SERVICE INFORMATION LETTER NO. 0091

Subject: Modification to Engine Starting System

Models F-28C prior to S/N 480 (except S/N 465); 280C prior to S/N 1183 (except S/N 1172)

FIG. 1

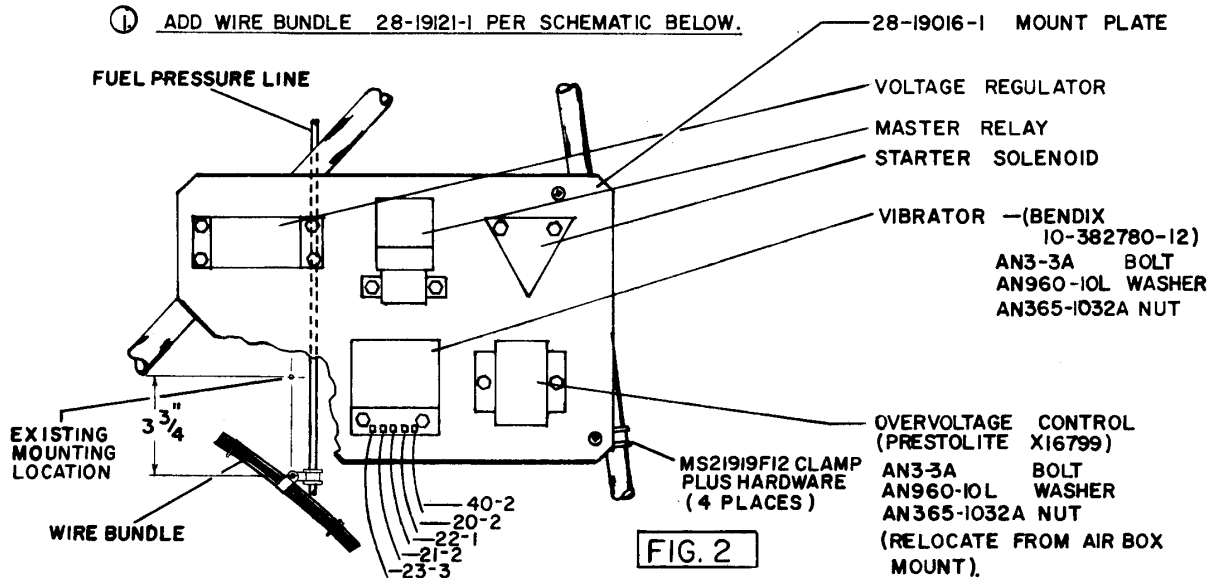
To improve the reliability of the starter and the starting characteristics of the Enstrom helicopter, the Bendix Model D2000 magneto has been replaced with Bendix Model D2200 magneto (P/N LW-385144-112) or 3000 series (P/N LW-682605-17) which utilize the electric retard (shower of sparks) starting system. The shower of sparks system provides more reliable starting and reduces the possibility of engine kick back, which has damaged some starter Bendix assemblies.

1. Disconnect wires from the components on the 28-19004-1 standard mount plate (Ref. figure 1).
2. Remove 28-19004-1 mount plate and attached components.

OLD INSTALLATION

REPLACED BY THIS INSTALLATION.

① ADD WIRE BUNDLE 28-19121-1 PER SCHEMATIC BELOW.

FIG. 2

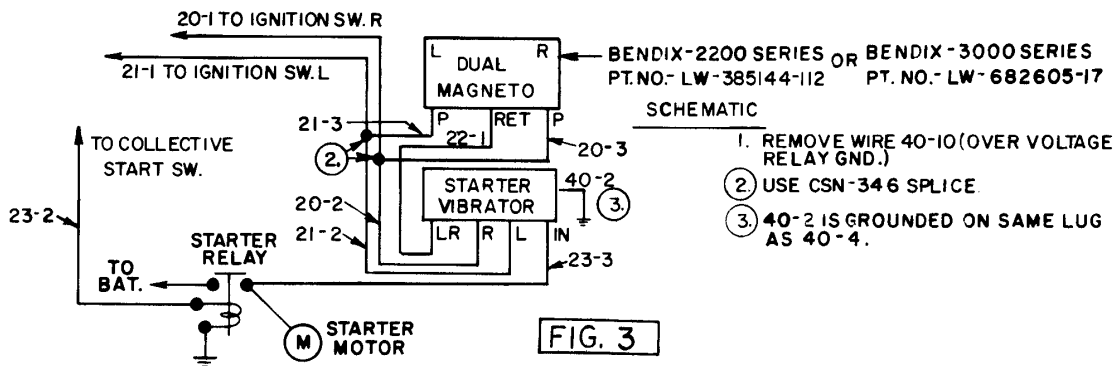
3. Remove all components and hardware from 28-19004-1 mount plate.
4. Assemble 28-19016-1 mount plate and components (Ref. figure 2, page 3, and drawing 28-19122, dated 6/25/80, supplied with kit).

5. Relocate fuel line clamp and wire harness clamps (2) (Ref. figure 2).
  - (a) Disassemble clamp assembly and discard smallest harness clamp (retain larger harness clamp for reassembly).

- (b) Slide fuel line clamp DOWN 3.75 inches. and use it as a guide to drill the new installation hole in the fire wall.
  - (c) Seal original mounting hole drilled in the firewall with (1) AN515-8R6 screw, (2) AN960-8L washers, and (1) AN363-832 nut. Install with bolt head on cabin side of firewall.

FIG. 3

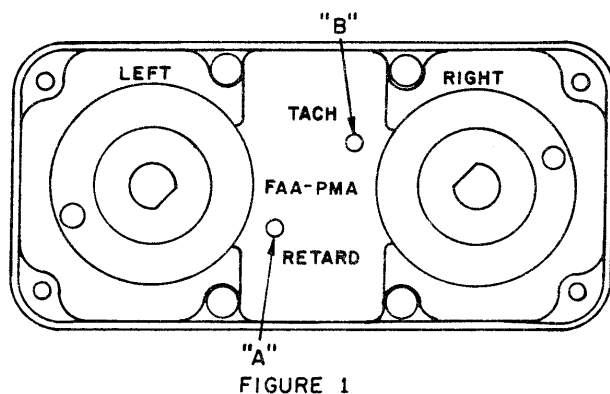
NOTE: Remove wire 40-10 over voltage relay ground (figure 3).
7. Cut 20-1 and 21-1 approximately 6 inches away from the "P" lead terminal.

NOTE: Number the remaining wire bundle ends of these wires with the same numbers.
8. Renumber the 6 inch "P" lead pigtails 20-3 and 21-3 respectively.
9. Splice (use CSN-346 splice provided) wires 20-1 and 20-2 (supplied with wire harness P/N 28-19121) to 20-3.
10. Splice (use CSN-346 splice provided) wires 21-1 and 21-2 (supplied with wire harness P/N 28-19121) to 21-3.
11. Solder furnished retard lead terminal wire to 22-1 in wire harness P/N 28-19121.
12. Tie and clamp 28-19121 harness with existing main wire harness.
13. Install 28-19016-1 mount plate (Ref. figure 2).
14. Terminate wires per figure 3 and drawing 28-19122 supplied with kit.

NOTE: Wire 40-2 is grounded on the same lug as 40-4.
